April 19, 2001
PY-CEI/NRR-2564L

Perry Nuclear Power Plant
Docket Nos. 50-440; 50-441
Submittal of Emergency Plan
Implementing Instructions

Manual: Emergency Plan Implementing Instruction (EPI) for Perry Nuclear Power, EPI -A-0001, R/6, C-5

PERRY NUCLEAR POWER PLANT ALTERNATE TECHNICAL SUPPORT CENTER LAYOUT

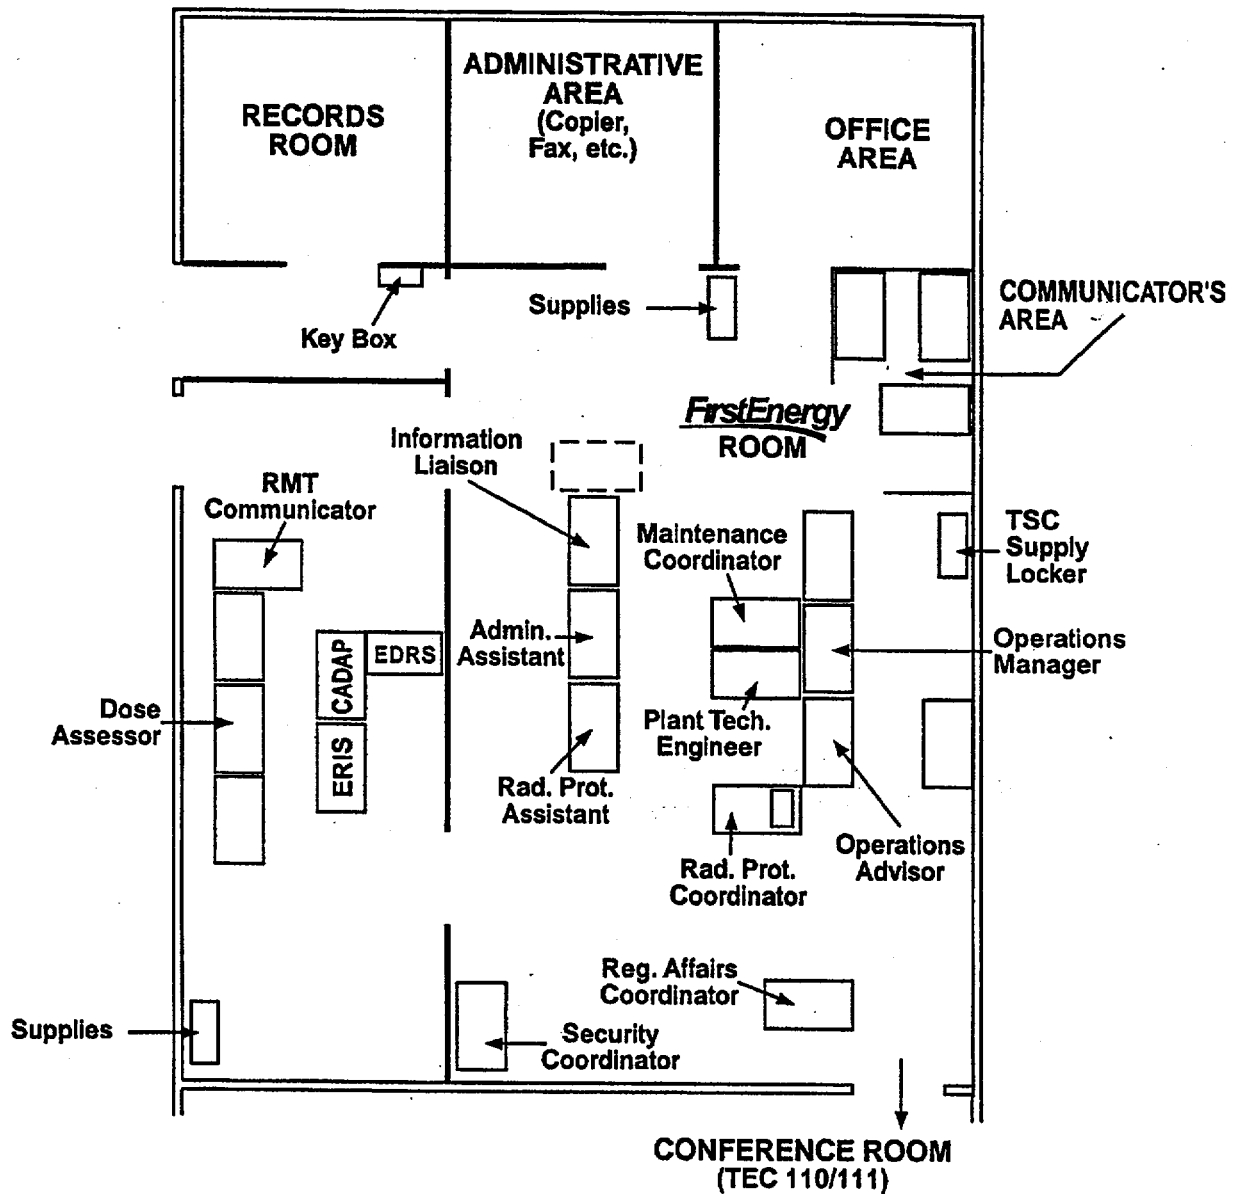
11. Alternate TSC Layout Figure (Attachment 2) revised to reflect Regulatory Affairs Coordinator position.
12. Specifies TSC Radiation Protection Coordinator responsibility for plant Chemistry activities, including core damage assessment, through the OSC Chemistry Supervisor or TSC Dose Assessor. [EP-96-11]
